Mobile Pentium® II Processor Specification Update

Release Date: April 1999

Order Number: 243887-009

New Mobile Pentium® II Processor in Mini-Cartridge Package Label with Supplier Matrix Mark Removed

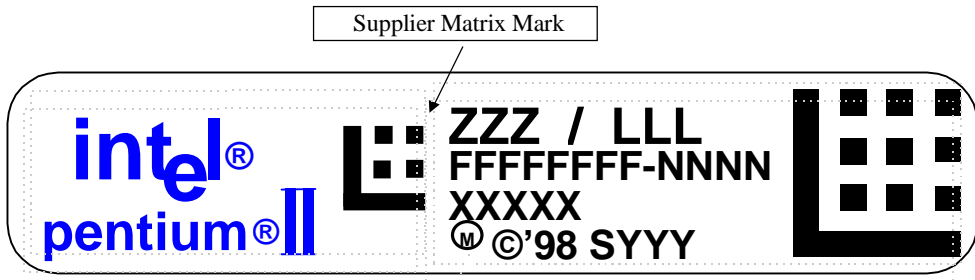
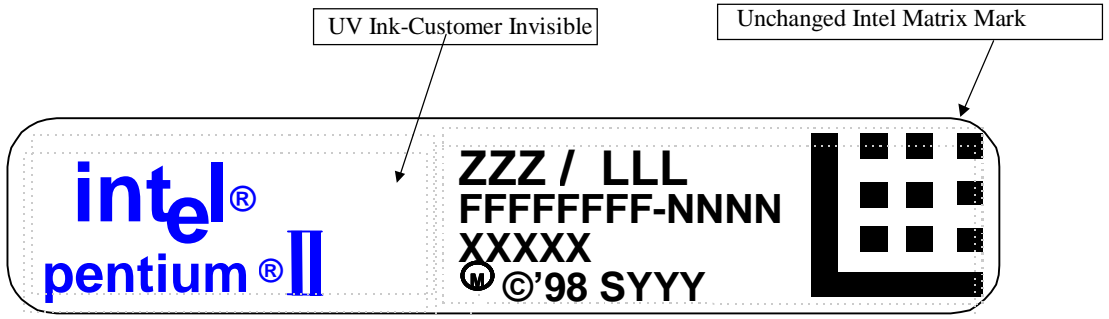
Old Mobile Pentium® II Processor in Mini-Cartridge Package Label with Supplier Matrix Mark

Figure 2. Workaround Flowchart: SMBALERT#-Driven System

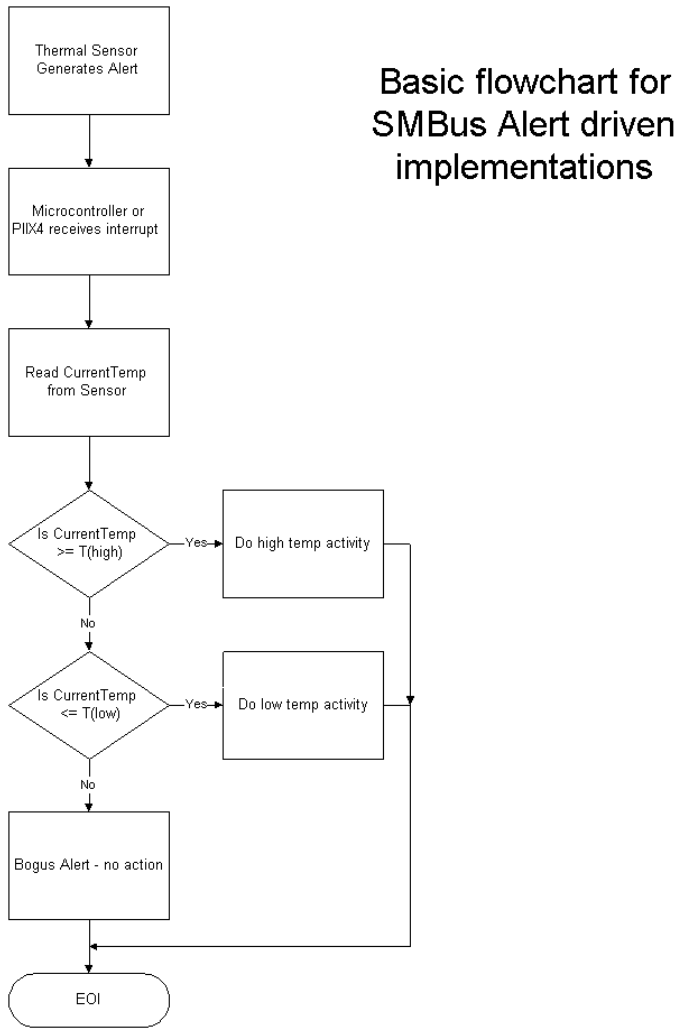
WORKAROUND: Three different (mutually exclusive) workarounds are possible:

1. Before servicing an interrupt from the thermal sensor, read and compare the processor thermal reading with the threshold limits (T_{HIGH} or T_{LOW}). Figures 2 and 3 provide basic flowcharts for the implementation of this workaround in an interrupt driven system.
2. If the firmware implemented polls the Status Register only, then before taking any action, re-read the temperature register and do a comparison with the alarm threshold limits (T_{HIGH} or T_{LOW}) to determine if the value is actually still within the temperature window.
3. Use a temperature polling scheme to monitor the processor temperature.

Figure 5.6. Cross Sectional View with Vertical Dimensions

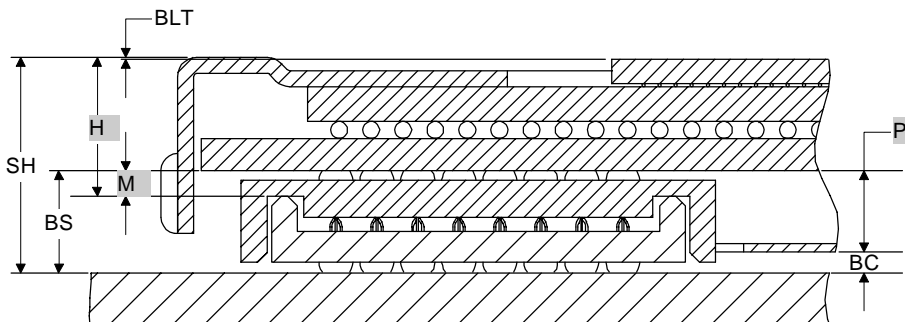
B2. Misabeled Vertical Dimension Parameters

Figure 5.6 in the *Mobile Pentium® II Processor at 233 MHz, 266 MHz, and 300 MHz* datasheet should be replaced by the following figure:

Figure 1. TAP Gageable Thread Clarification

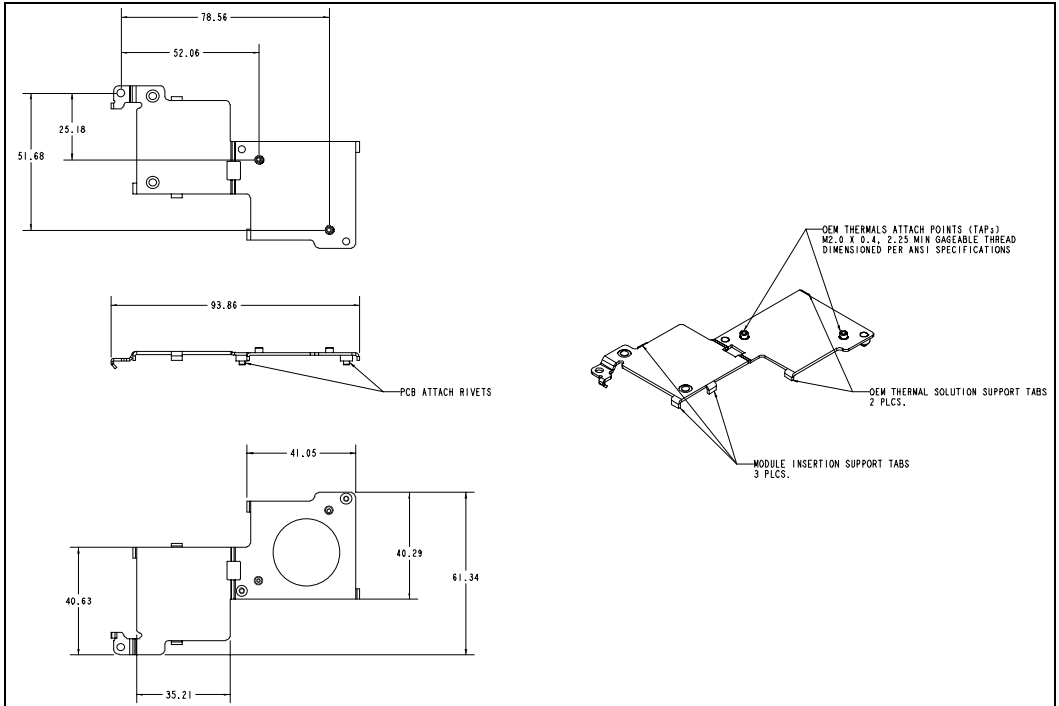
In the *Intel® Pentium® II Processor Mobile Module : Mobile Module Connector 1 (MMC-1)* and *Intel® Pentium® II Processor Mobile Module : Mobile Module Connector 2 (MMC-2)* datasheets (Order Numbers 243667 and 243668 respectively), the thermal attach point (TAP) gageable thread specification was not clearly identified in Figure 14, of Section 5.2. The following is the TAP clarification:

OEM Thermal Attach Points (TAPs) M2.0 x 0.4, 2.25 min gageable thread dimensioned per ANSI specification.

See Figure 1 below for more information.
